Addendum No. (3)

Reference: SEZAD Tender No. 21/2014 "Design and Construction of an Integrated Waste Treatment Storage and Disposal Facility at Duqm"

Subject: Responses/Clarifications to Queries

TENDER NAME: Design and Construction of an Integrated Waste Treatment, Storage and Disposal Facility in Duqm Zone (SFZ)

Example: Details of Cell Lining system as per USEPA.

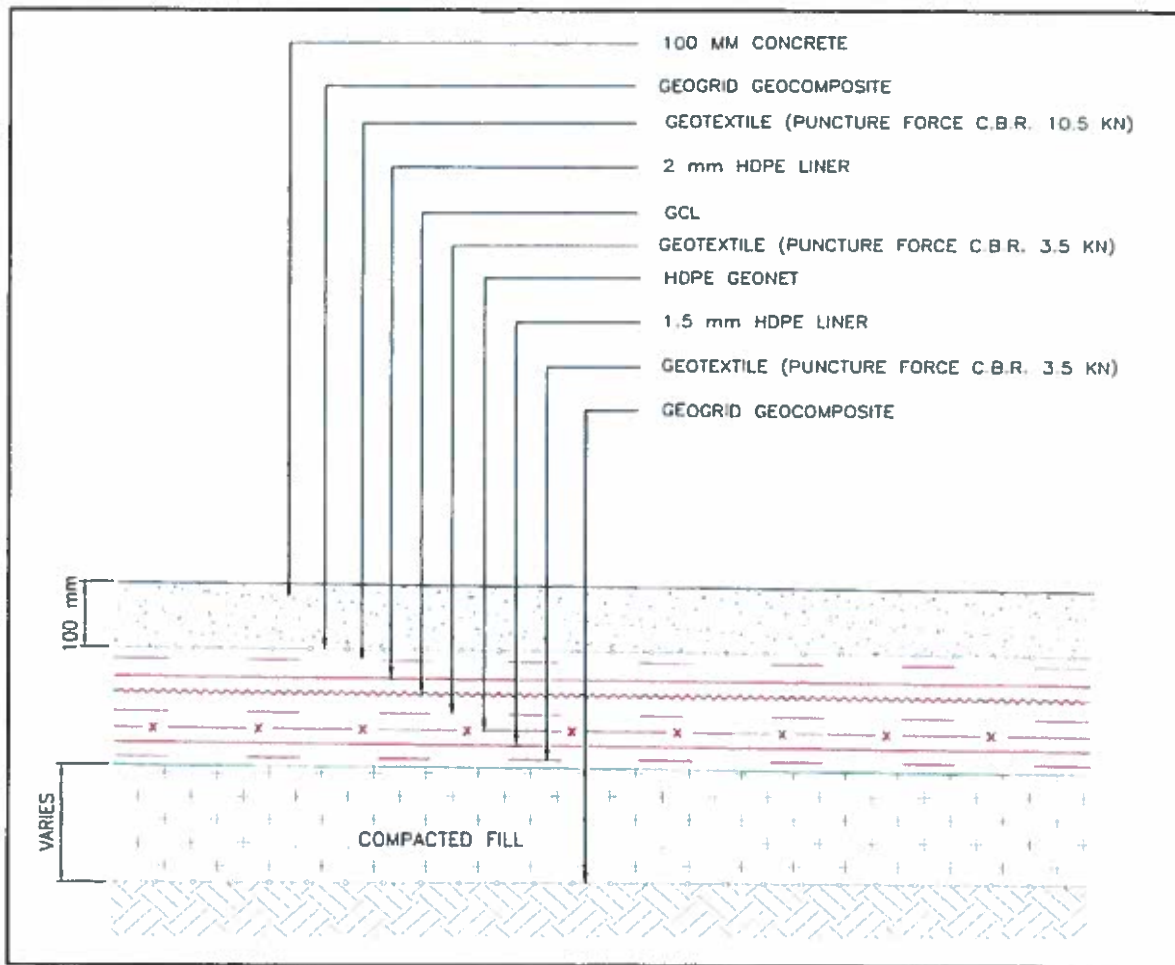
| Sr. No. | Ref. RFP Section | Query | Response |
|---------|---|--|--|
| 1 | Part 3, Scope of Work, Pg. no. 44, Clause 2.9.3 | INDUSTRIAL WASTE BASAL LINING SYSTEM: As per clause, High strength geotextiles (CBR \geq 5.5 KN) meeting the particular specifications forming the part of basal lining system. However, we do not find this item in "details of lining system", "particular specifications" and "APPENDIX II, Schedule of Prices". Kindly clarify if we are required to consider it as geotextile (CBR=3.5 KN) or geotextile (CBR=5.5 KN). | <i>Please consider this geotextile layer as type one (CBR 3.5 KN) An amended description of the industrial waste landfill basal lining system is attached (Attachment 1) as well as a hard and soft copy of the amended Schedule of Prices(Attachment 2)</i> |

Example: Evaporation pond lining system as per USEPA (for MSW and industrial waste landfills)

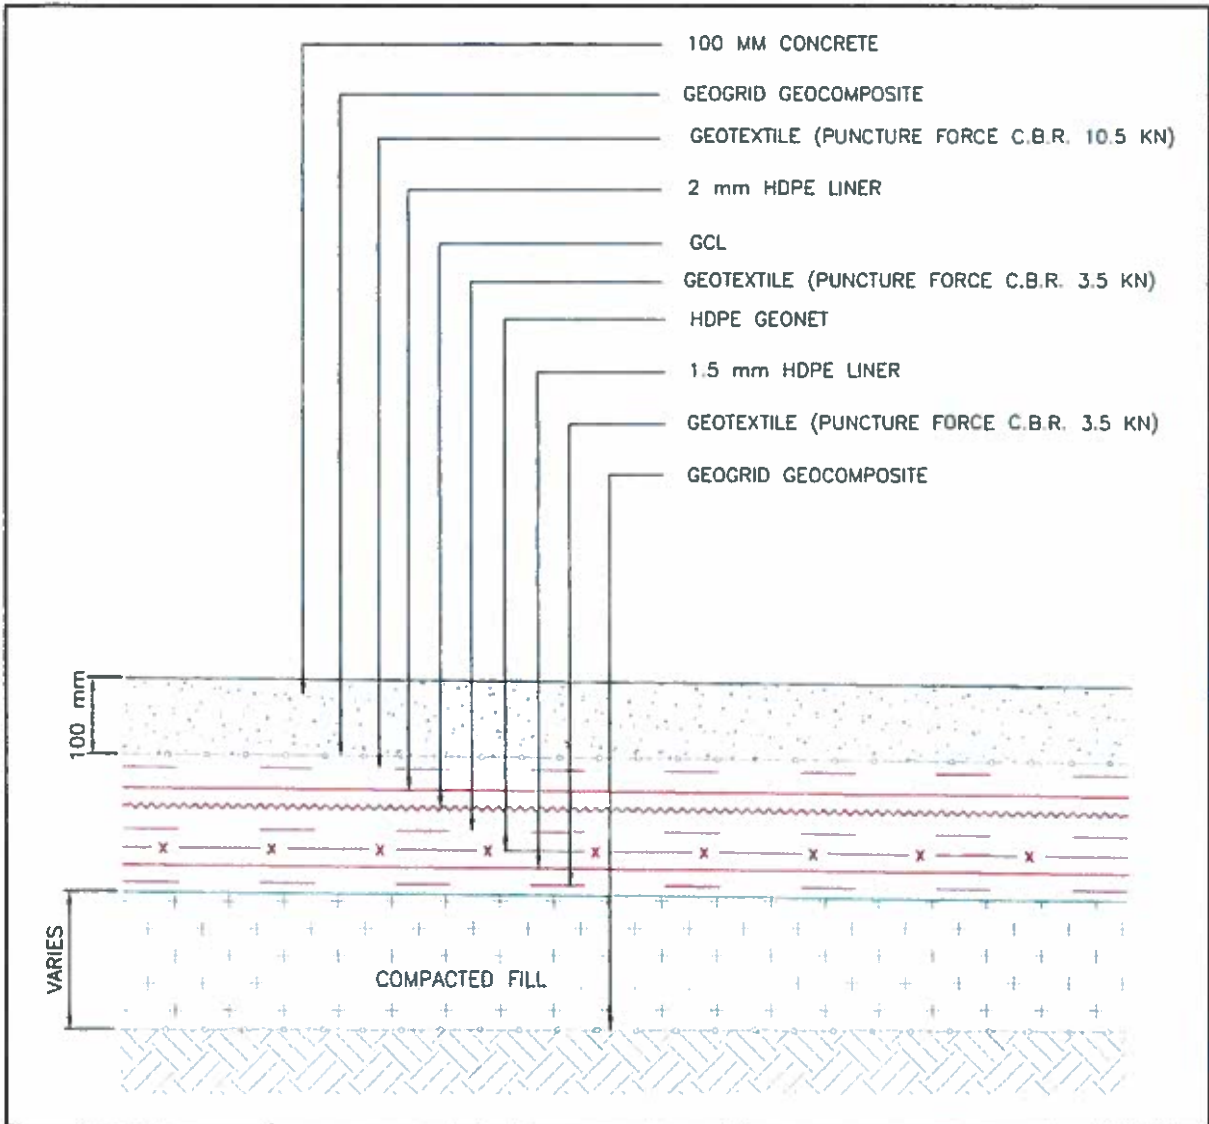
| Sr. No. | Ref. RFP Section | Query | Response |
|---------|---|--|--|
| 4 | APPENDIX II, Schedule of Prices, TABLE 5.A and 5.B | Table 5. A – GENERAL AND MSW LANDFILL - EVAPORATION PONDS-Geo-synthetics lining system and Table 5.B - 'INDUSTRIAL WASTE' EVAPORATION PONDS- Geosynthetics lining system The item TYPE II Geotextile (CBR=10.5 KN) is missing in above tables of Schedule of prices. The drawing of Evaporation pond lining system as per USEPA shows provision of Type II – Geotextile (10.5 KN). Kindly include the same in Schedule of Prices. | <i>Type II Geotextile has been included in the attached amended Schedule of price (Attachment 2). An amended design requirements for the lining system of both evaporation ponds for General and industrial waste landfills is attached (Attachment 3)</i> |
